Subject: **ENERGY COMMISSION STAFF'S REBUTTAL TESTIMONY
IVANPAH SOLAR ELECTRIC GENERATING SYSTEM (07-AFC-5)
Exhibit 305**

SUMMARY

Energy Commission staff is providing the following Rebuttal Testimony in the technical areas of Alternatives and Biological Resources. This testimony is organized as follows:

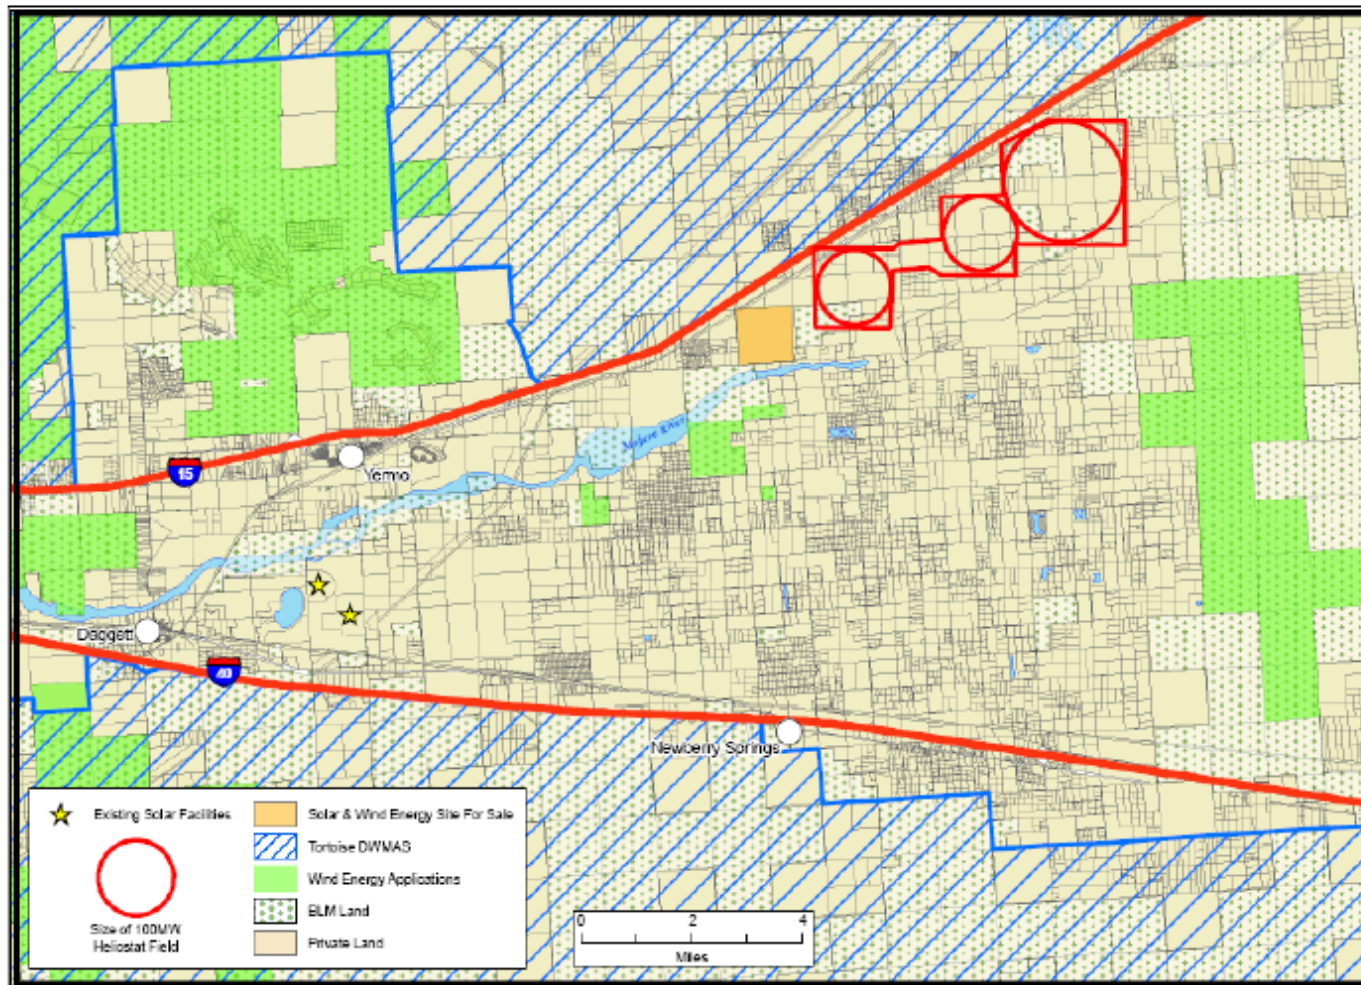
Based on a GIS analysis of the I-15 Alternative, 3,122 acres occur above 2,800 feet elevation, which corresponds roughly to the elevation above which a transition was observed in important habitat characteristics relevant to the special-status plants found in the project vicinity (see **Rebuttal Testimony Figure 6** at the end of Section 2, Testimony of Susan Sanders). Specifically, there is a noticeable shift from habitat that includes the important microhabitat characteristics associated with the special-status plants (as observed in the nearby reference populations), to habitat where most or all of these characteristics drop out: many of the ephemeral washes abate in the landscape, the topography flattens, there is a lowering of species diversity, a shift in the plant community at the association level, vegetative cover is more open, and cacti and succulents completely drop out of the species composition.

The analysis was based on the assumption that the entire I-15 Alternative would be utilized for heliostat fields and other project components. The FSA did not include an assessment of any subset of the I-15 Alternative but noted (and described above) that

the habitat was of a poorer quality at the lower elevations in the northern portion of the Alternative (1,528 acres surrounding and proximal to the golf course).

These conclusions are based on an analysis of habitat suitability for special-status plants; this assessment should be confirmed by special-status plant surveys in spring 2010.

ALTERNATIVES - FIGURE 6
ISEGS - I-15 Alternative

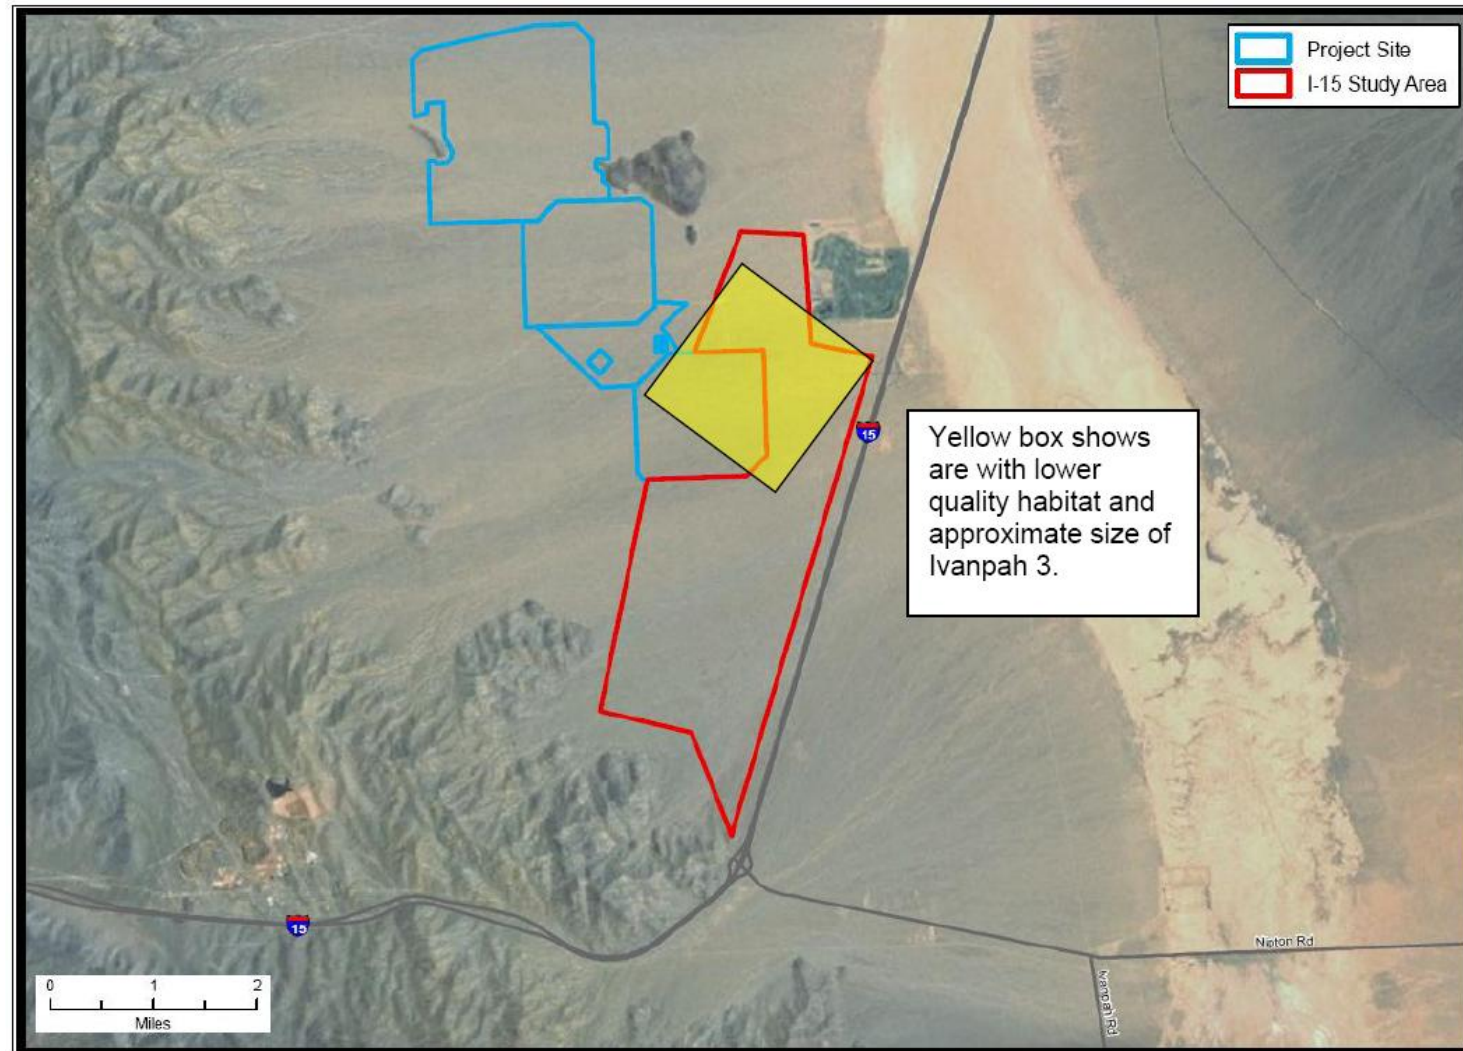
The Sierra Club and other intervenors state that the staff analysis of the I-15 Alternative in the FSA is inadequate because it concludes that the impacts of moving the ISEGS project to the alternative site would not be reduced in comparison with the proposed site. The I-15 Alternative (as illustrated on Alternatives Figure 6, reproduced at the end of this testimony) includes the majority of Ivanpah Phase 1 in order to have the required total acreage. As illustrated in Alternatives Figure 6, Staff's definition of the I-15 Alternative (also known as the Sierra Club Alternative) in the FSA was based on the

Sierra Club's definition in its June 2009 letter to BLM: an "... alternative that ... relocated the Project's three power blocks closer to the areas adjacent to Interstate 15 currently mapped as translocation sites...". The Sierra Club did not provide a map of the suggested alternative. Staff established the eastern boundary of the I-15 Alternative approximately 1,000 feet from the freeway to avoid conflict with the Caltrans Joint Port of Entry facilities that are proposed to be located along the freeway at this location.

Reduced Acreage Alternative: From PSA Workshop Presentation (July 31, 2009)

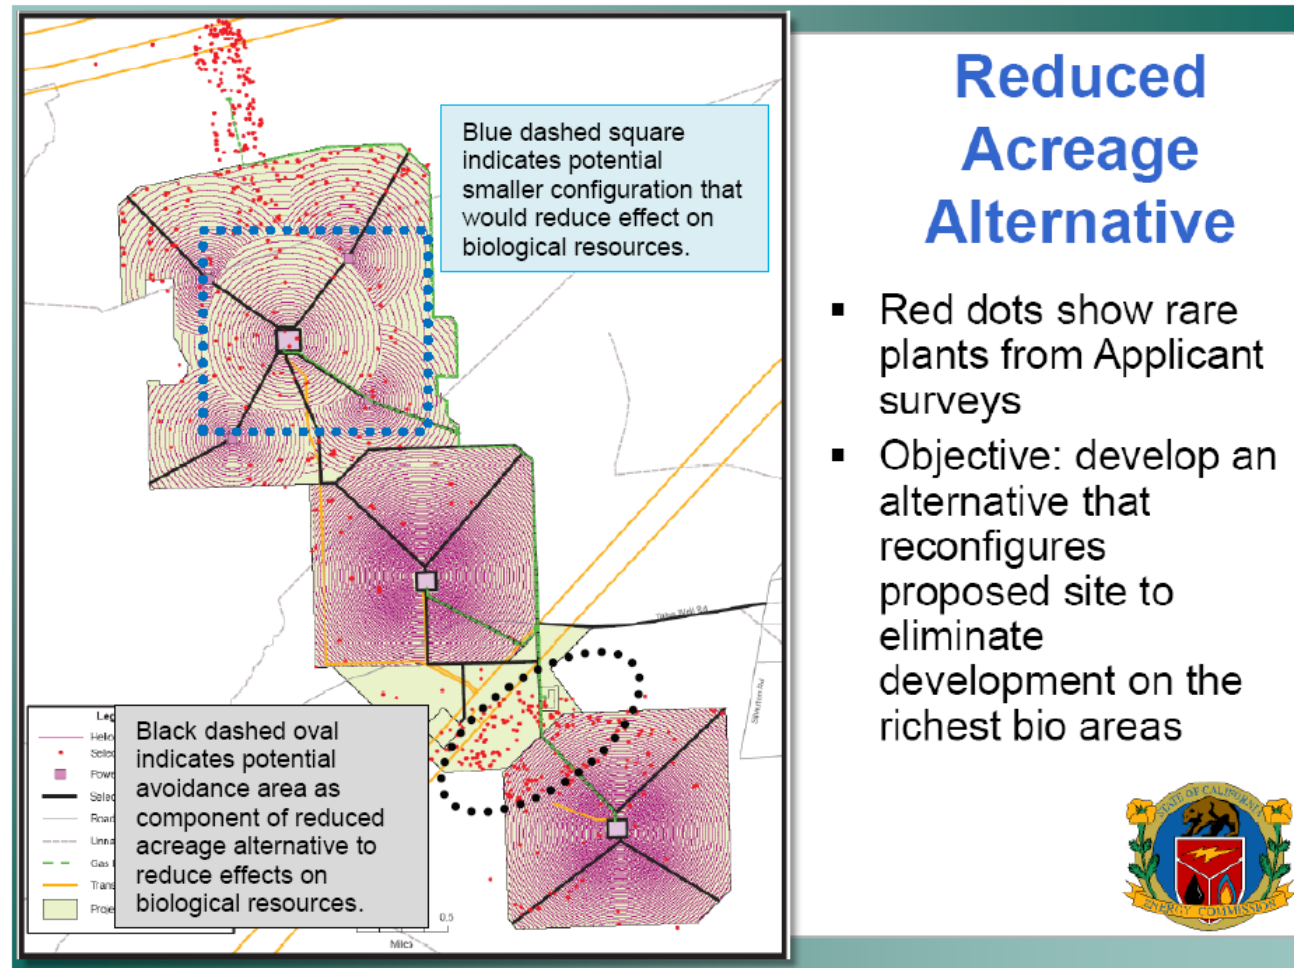
As a result of the uncertain implementation of BIO-18, staff requests applicant and intervenor consideration of the Reduced Acreage Alternative, which would provide far more certain protection for some of the highest concentrations of special-status plant species occurrences. This alternative would remove at least two areas from any development effects: (1) portions of Ivanpah 3 (especially the northern area), and (2) portions near the transmission corridor and laydown area, and the northwestern part of Ivanpah 1. These areas are illustrated in **Rebuttal Testimony Figure 3**, a map presented for discussion at the July 31, 2009 PSA Workshop (attached at the end of this rebuttal testimony). The black dashed box and blue dashed oval are the areas suggested for avoidance under this alternative.

Rebuttal Testimony Figure 4

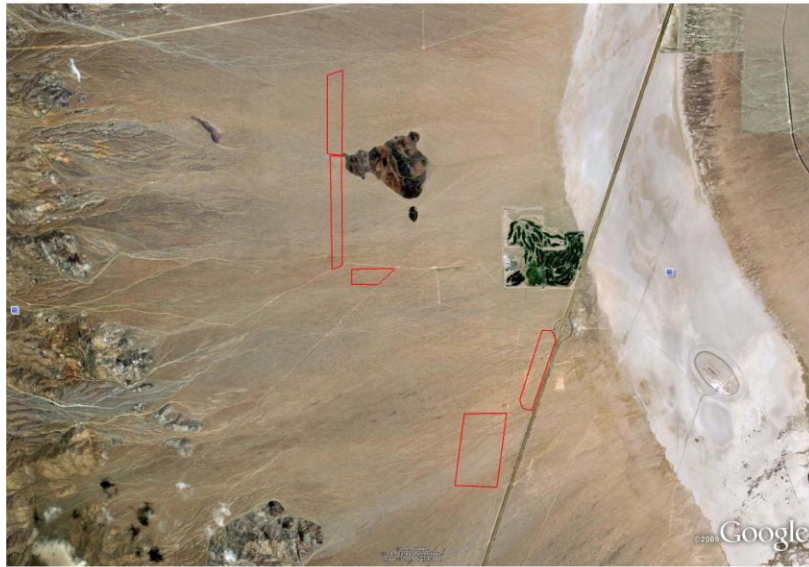
some elements of the methods used to assess desert tortoise densities. The Sierra Club biologists used a line-transect method to survey for desert tortoise burrows and other sign within approximately 316 acres of the I-15 Alternative, and approximately 233 acres within the proposed Project site. Exhibit 604 of the Sierra Club testimony shows the location of sampling locations, and is included here as **Rebuttal Testimony Figure 4** at the end of this testimony.

For the Sierra Club sampling method to reasonably represent desert tortoise habitat conditions and densities of the approximately 4,000-acre I-15 Alternative, the sampling units selected would need to be similar to habitat conditions throughout the site. Sierra Club offers no explanation as to how the sampling locations were selected, but a review of the USGS model for desert tortoise habitat in **Rebuttal Testimony Figure 5** indicates that at least the northernmost sampling unit is in some of the poorest desert tortoise habitat in the area, and is not representative of most of the desert tortoise habitat in the I-15 alternative. **Rebuttal Testimony Figure 5** is from information submitted by the applicant in August 2009 to address suitability of habitat at proposed desert tortoise translocation sites, and depicts the results of a USGS desert tortoise habitat model (Nussear et al. 2009) applied to the project site and surrounding areas. This model shows that much of the I-15 Alternative site is good quality desert tortoise habitat, consistent with the description of the site in the FSA/DEIS and in Richard Anderson's testimony. Based on the a review of **Rebuttal Testimony Figure 4** and **Rebuttal Testimony Figure 5**, the Sierra Club's northern sampling unit is located in one of the few patches of poor desert tortoise habitat present in the I-15 Alternative area. Furthermore, in reviewing **Rebuttal Testimony Figure 4** which shows the location of the Sierra Club survey areas, it appears that some or all of their northern sampling site may be outside of the boundaries of the I-15 Alternative surveyed by staff. As shown in Figure 6 from the Alternatives section of the FSA/DEIS (included as **Rebuttal Testimony Figure 2** in Section 1, Susan Lee's Rebuttal Testimony), the eastern boundary of the I-15 Alternative study area was shifted 1000 feet away from the freeway to avoid overlap with the proposed Joint Port of Entry Project, but the one of the Sierra Club sampling areas was placed immediately adjacent to the freeway.

REBUTTAL TESTIMONY - FIGURE 6
 Ivanpah Solar Electric Generating System
 Contour Map of the ISEGS Project and the Proposed I-15 Alternative

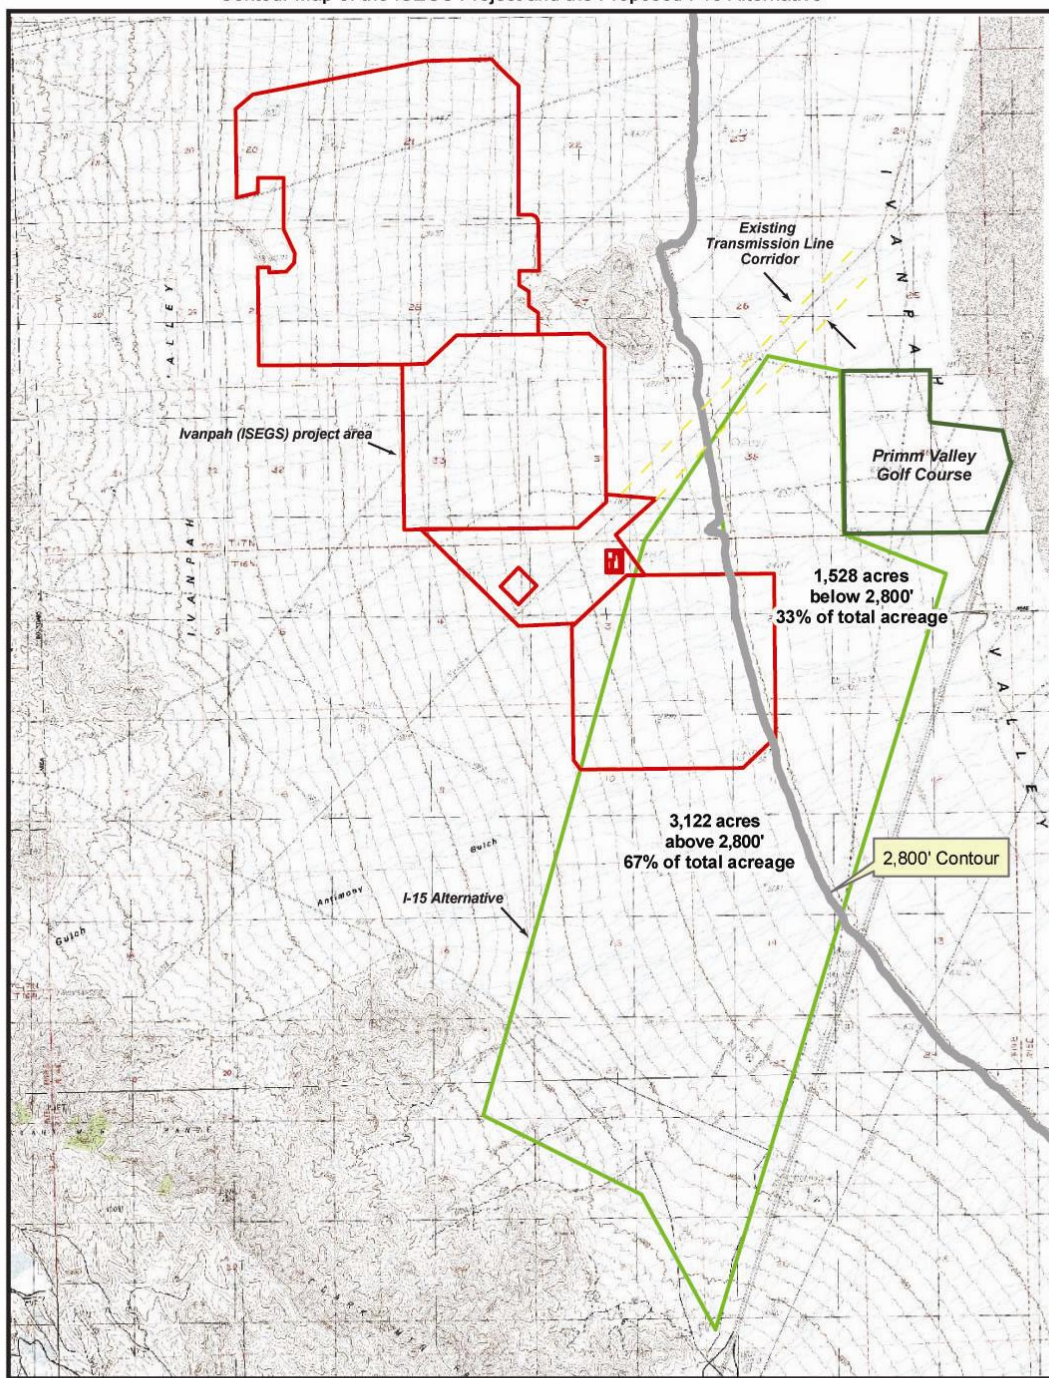
Rebuttal Testimony Figure 6 (Desert Tortoise Habitats, Relocation and Translocation Areas; copy provided in Biological Resources Rebuttal Testimony) identifies most of the I-15 Alternative area as being in very high potential desert tortoise zones. The area with lowest potential is immediately south and west of the golf course, the same areas as the portion below 2,800 feet of elevation.

Construction on approximately 1,500 acres east of Ivanpah 1, below the 2,800 foot elevation contour line (see **Rebuttal Testimony Figure 6** at the end of this testimony), would likely result in far fewer impacts to special-status plants and other sensitive plant communities. Similarly, the lower elevation portions of the I-15 Alternative near the Primm Golf Course provide relatively low quality habitat for desert tortoise, and construction here rather than on the ISEGS site might substantially reduce impacts to desert tortoise.

BIOLOGICAL RESOURCES - FIGURE 2
ISEGS - Conceptual Approach to Special-Status Plant Avoidance

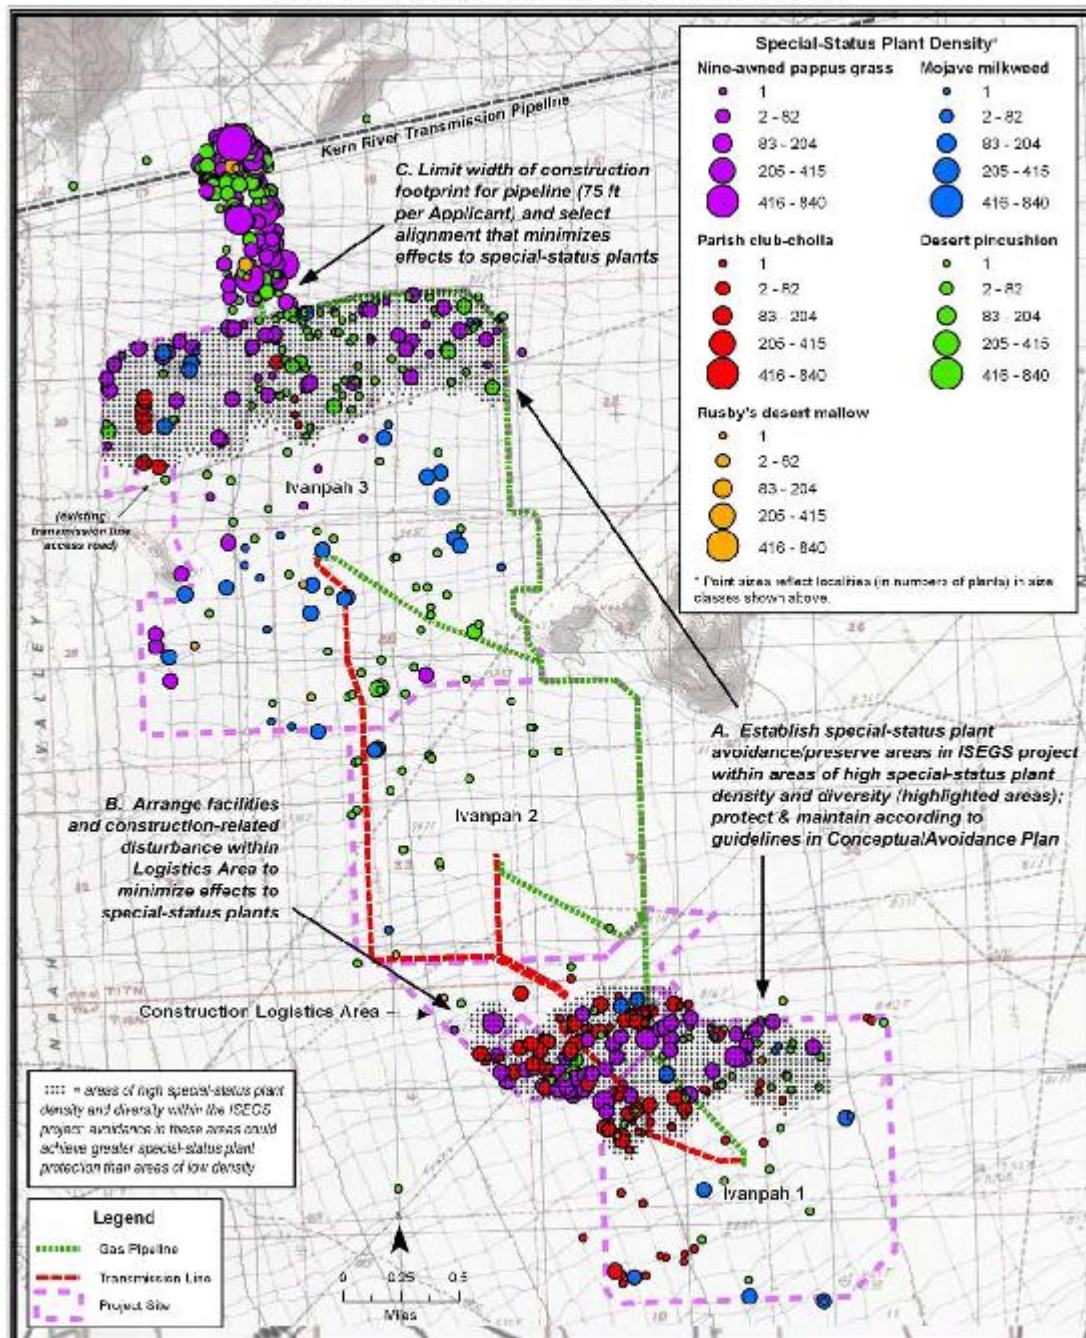
In consideration of comments on the PSA, staff also developed a Reduced Acreage Alternative, as explained in the FSA on pages 4-52 and 4-53. **Rebuttal Testimony Figure 7** (FSA Biological Resources Figure 2) illustrates the distribution of rare plants on the proposed site; the distribution of these plants was a major concern in the development of this alternative.

The applicant's testimony rejects staff's proposed mitigation by avoidance of special-status plants as infeasible, but this basis for rejection is based on a misreading of staff's testimony. The applicant's testimony states "Complete loss of significant portions of Ivanpah 1 and 3 such as that suggested in FSA/DEIS Biological Resources Figure 2 is not possible without compromising design to an unacceptable level." Figure 2 is included here as **Rebuttal Testimony Figure 7** at the end of this section. To clarify the text on this figure, the dotted areas marked "A" indicate areas of high special-status plant density and diversity *within which* avoidance areas could be designated and achieve greater protection compared to areas of low density. Staff made no recommendations as to the specific project reconfiguration that might occur because information on the applicant's engineering constraints is lacking. However, staff's intent was for the applicant to select areas within these dotted areas that would be protected from development, preferably preserving areas along the edges of the project, contiguous with the adjacent, undisturbed habitat rather than imply the absence of project facilities in the entirety of the dotted areas.
